Access Compliance Report

Public Rights-of-Way

(Curb Ramps)

Intersection ID: 45862	Main Street: JAMISON_LN	Cross Street: HENDERSON_OAKS_DR	Location: W
ADA ID: 7E7AB5D8669A	Ramp Type: Perp	Initial Pass/Fail: Fail	Overall Compliance: No
Severity Score: 21.25			
Codes/Mitigation Info/Possible Solution		Field Measurements/Component Compliance

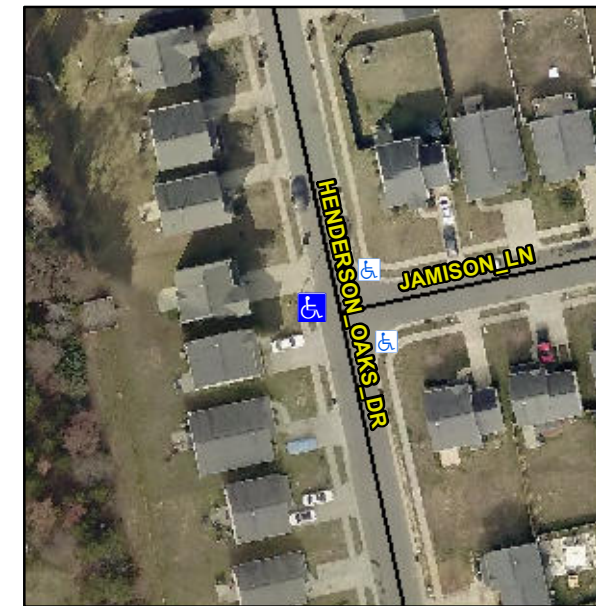
Not Found, R304.5.1, R304.2.2

Compliance	Description	Data	Compliance	Description	Data
N/A	Ramp Length (in)	47.5	No	Ramp Slope (%)	9.7
No	Ramp Width (in)	47.5	Yes	Ramp XSlope (%)	0.9
N/A	Flare Type LT	N/A	N/A	Flare Type RT	N/A
N/A	Flare Slope LT (%)	N/A	N/A	Flare Slope RT (%)	N/A
N/A	Flare Traversable LT?	N/A	N/A	Flare Traversable RT?	N/A
N/A	Landing Length (in)	N/A	N/A	DWS Provided?	N/A
N/A	Landing Width (in)	N/A	N/A	DWS Contrast?	N/A
N/A	Landing Slope (%)	N/A	N/A	DWS Length (in)	N/A
N/A	Landing X Slope (%)	N/A	N/A	DWS Full Width?	N/A
N/A	Landing Curb? (Y/N)	N/A	N/A	DWS Offset (in)	N/A
N/A	Shared Landing?	N/A			
N/A	Gutter Ponding?	N/A	N/A	Gutter Slope (%)	N/A
N/A	Gutter Lip Ht (in)	N/A	N/A	Gutter X Slope (%)	N/A
N/A	Painted X Walk1?	No	N/A	Painted X Walk2?	N/A
	X Walk 1 Direction	To E		X Walk 2 Direction	N/A
N/A	X Walk 1 Width (in)	N/A	N/A	X Walk 2 Width (in)	N/A
	X Walk 1 Slope (%)	2.6		X Walk 2 Slope (%)	N/A
	X Walk 1 X Slope (%)	1.5		X Walk 2 X Slope (%)	N/A

Remove & Replace Entire Ramp.
